# **BUTTE REGIONAL TRANSIT OPERATIONS CENTER**

Tenant Improvement

## **ADDENDUM NO. 3**

1/18/2016

**A601**

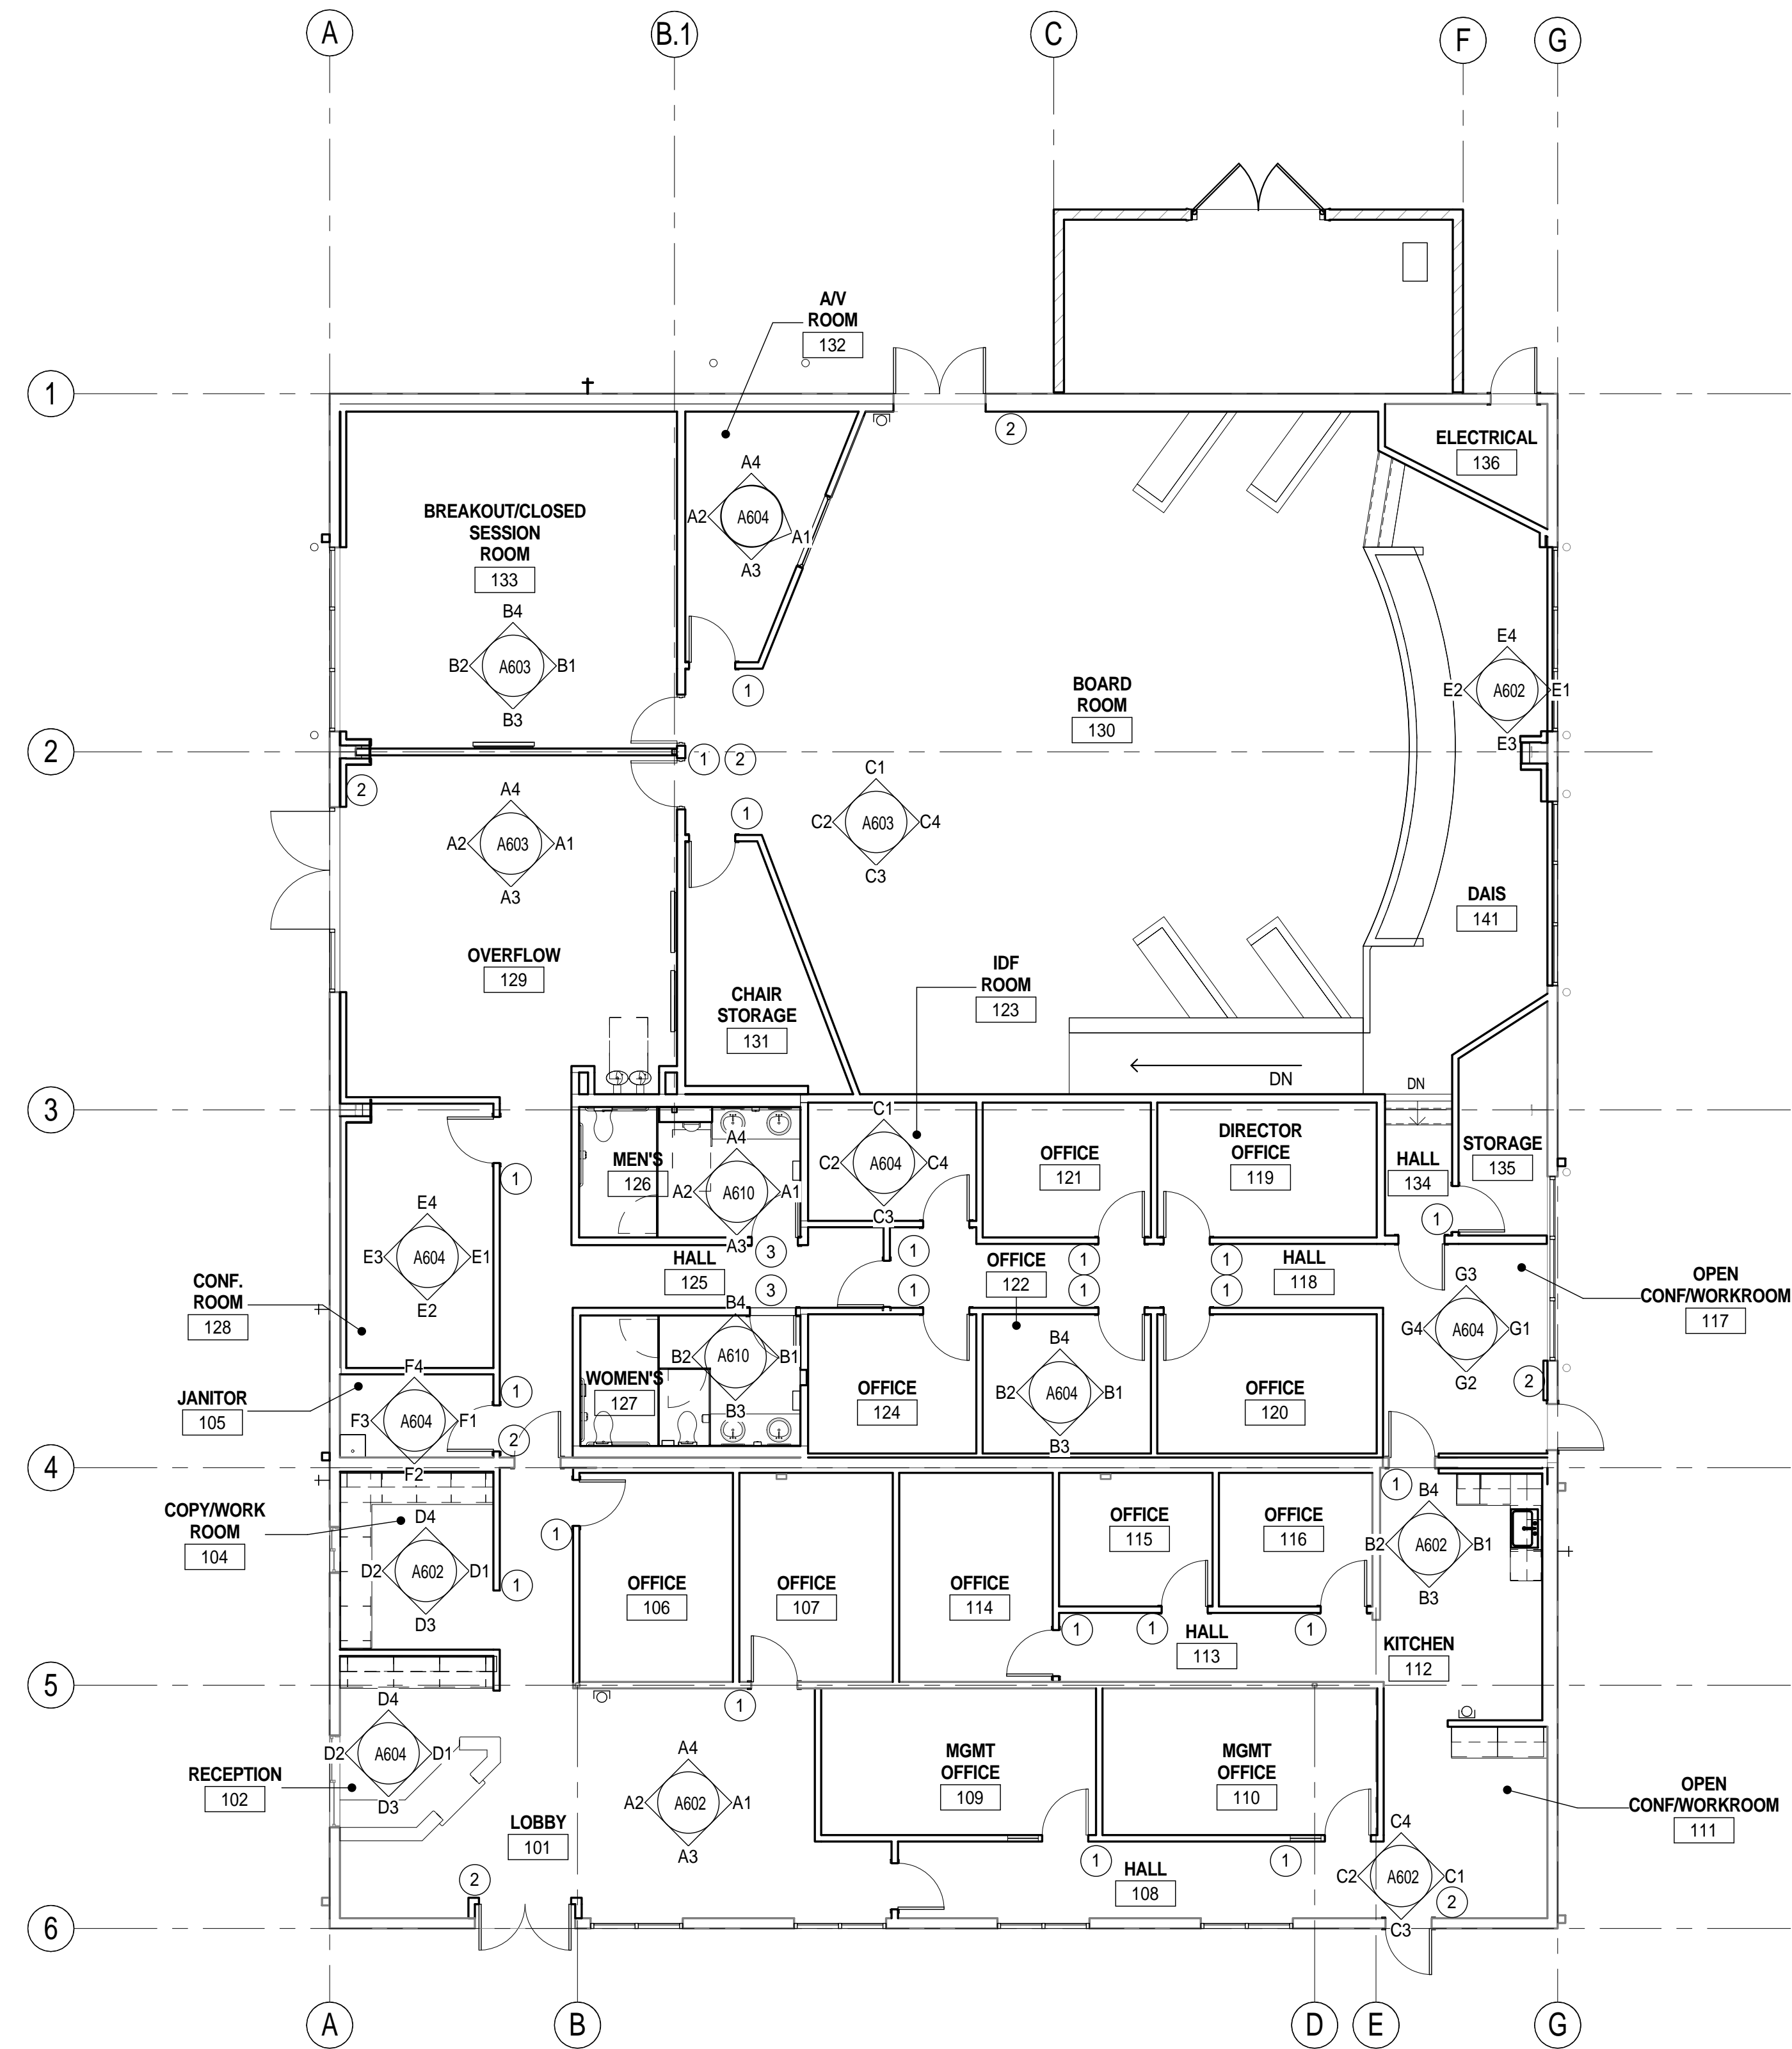
- 1.4 REVISION TO DRAWING A601 – SIGNAGE PLAN & ROOM FINISH SCHEDULE
  - a. ROOM FINISH SCHEDULE – The floor finish in room 133 has been revised

**6 CONCRETE DRILLED PIER FOOTING AT UTILITY YARD**  
3/4" = 1'-0"

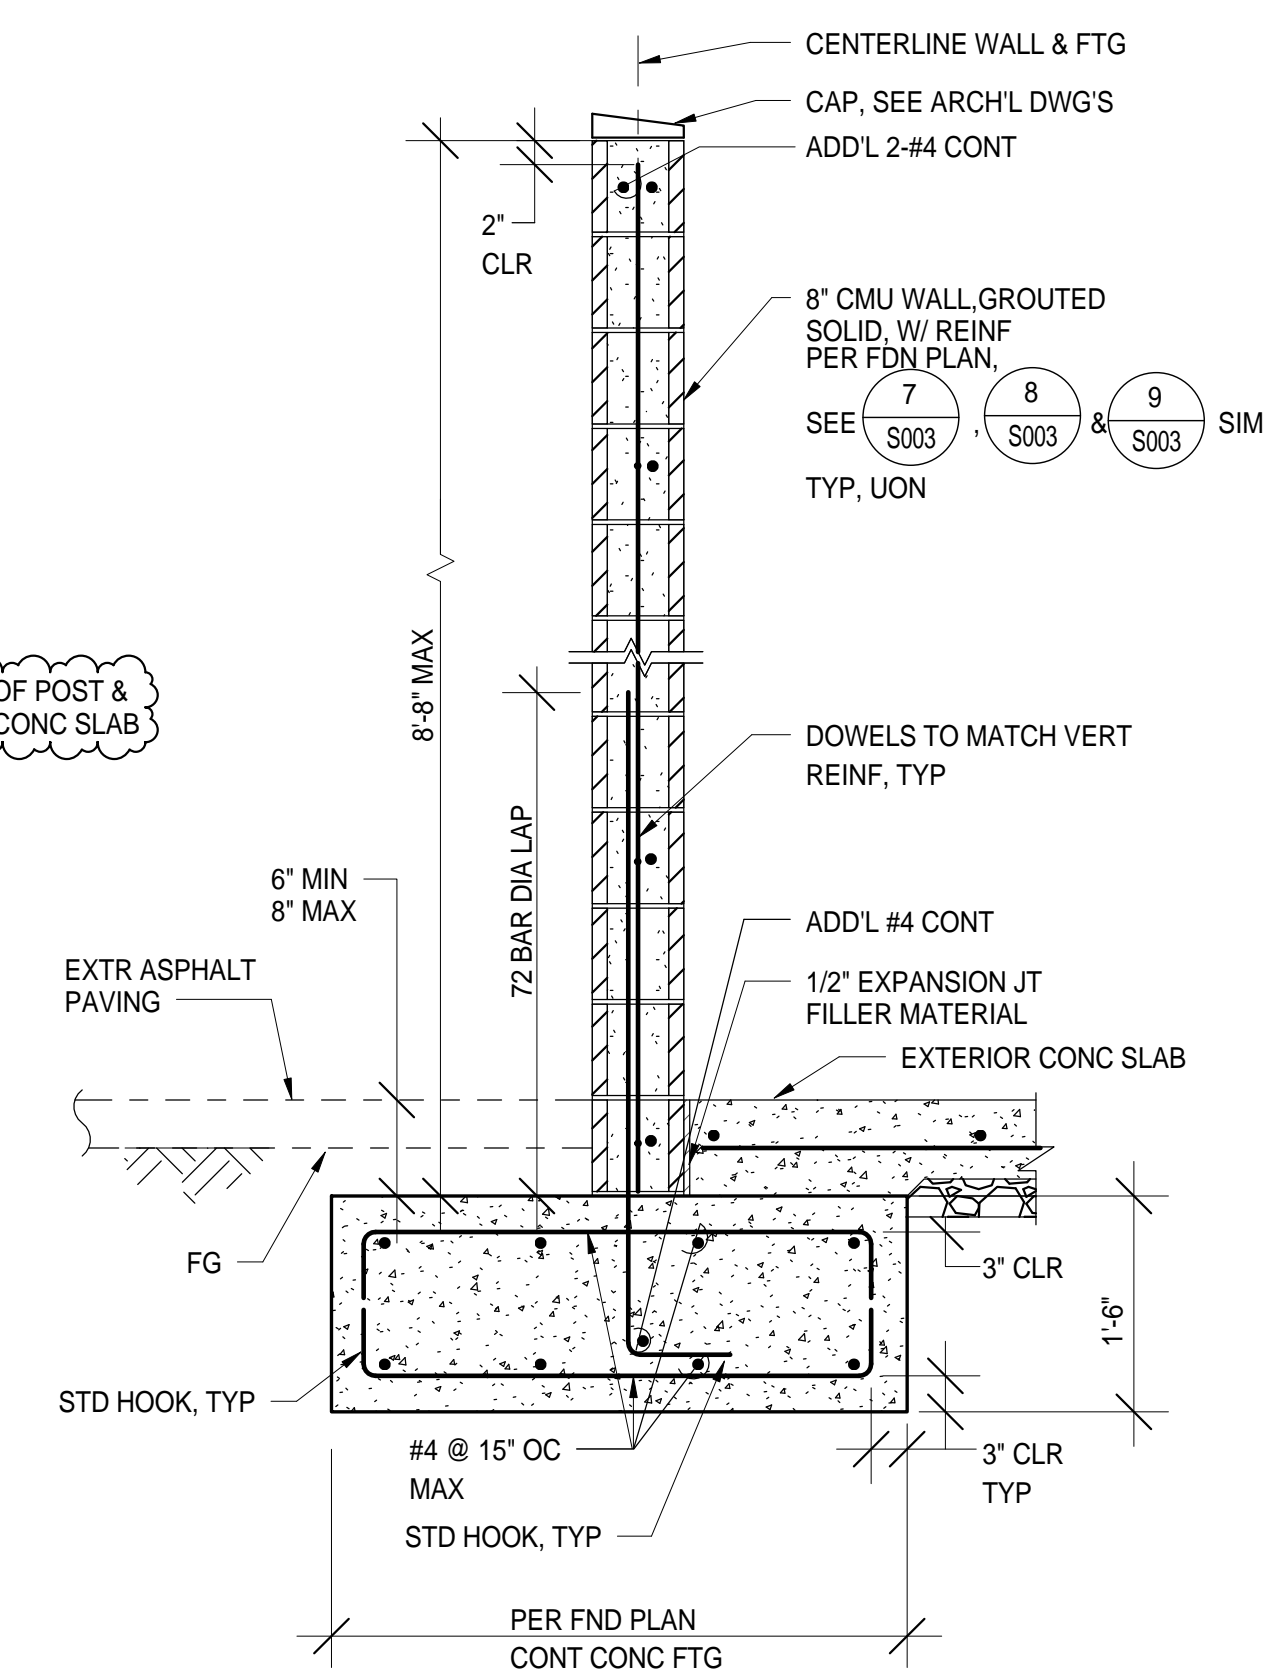
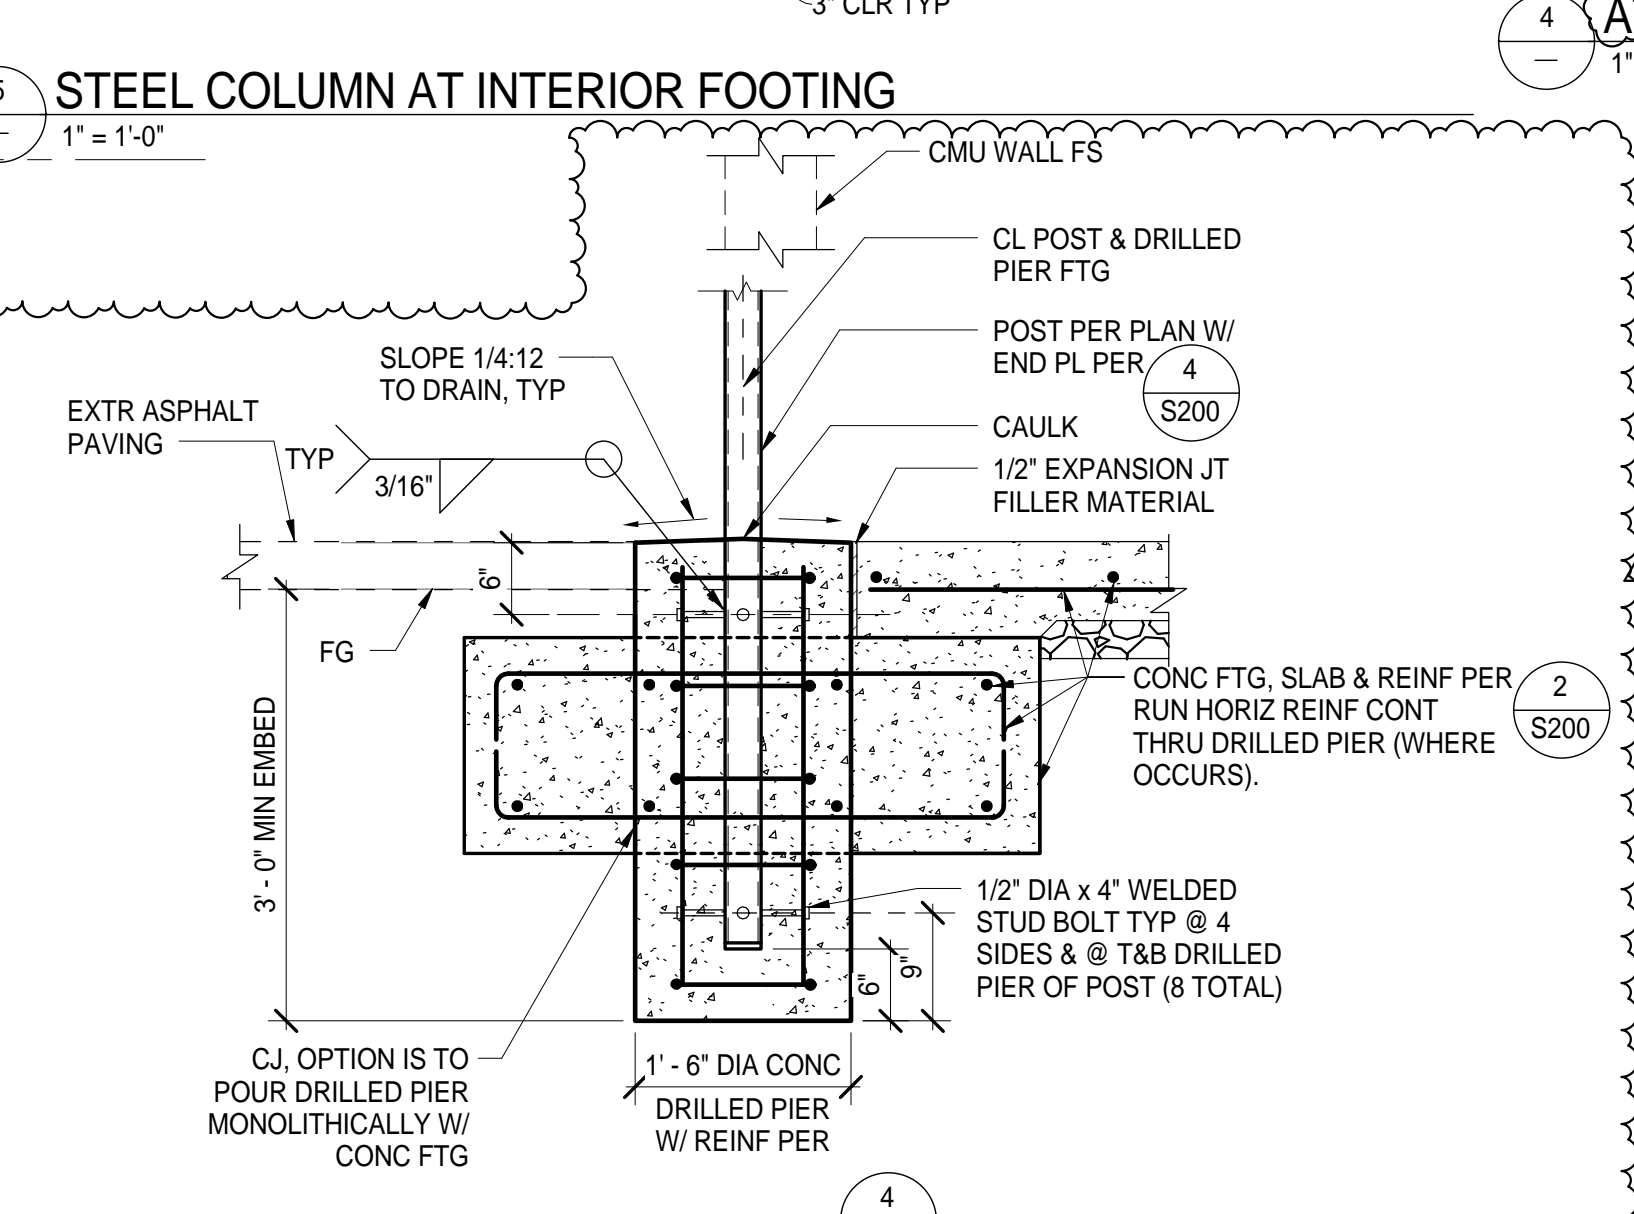
- 1.6 REVISION TO DRAWING S200 – FOUNDATION PLAN & DETAILS
  - a. Plan 1 - added reference callout to new interior spread footings on gridline B.1 and added gate post size and drilled pier information at utility yard. Detail 4 - added description to clarify location of concrete drilled pier footing. Added detail 6 for concrete drilled pier footing at utility yard.
